将 MFH-3 改成 MOFH-3 (VL/VL0)，步骤如下：

MFH-3-..., MOFH-3-...

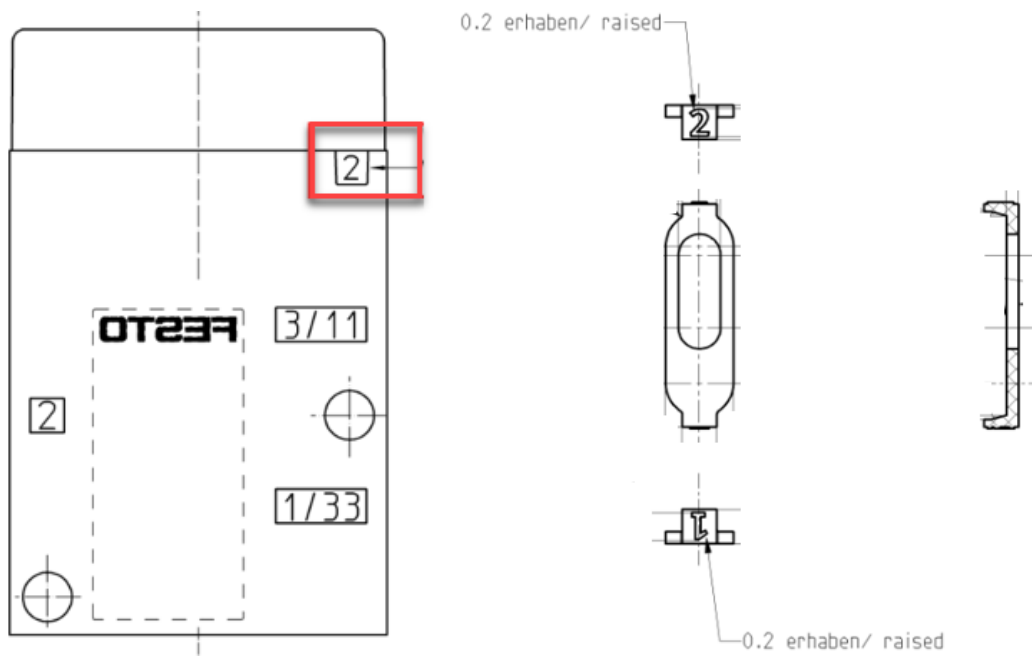
- 1、拧松先导头两个螺丝，拆下先导头，将内部密封垫旋转 180 度，密封垫上有标号，此时将标号 2 朝外放置。
- 2、改变气口连接方式，气口 11 进气，气口 33 排气。

密封垫选转180度

阀体上密封垫显示“1”，则表示 **MFH/VL**  
 阀体上密封垫显示“2”，则表示 **MOFH/VLO**
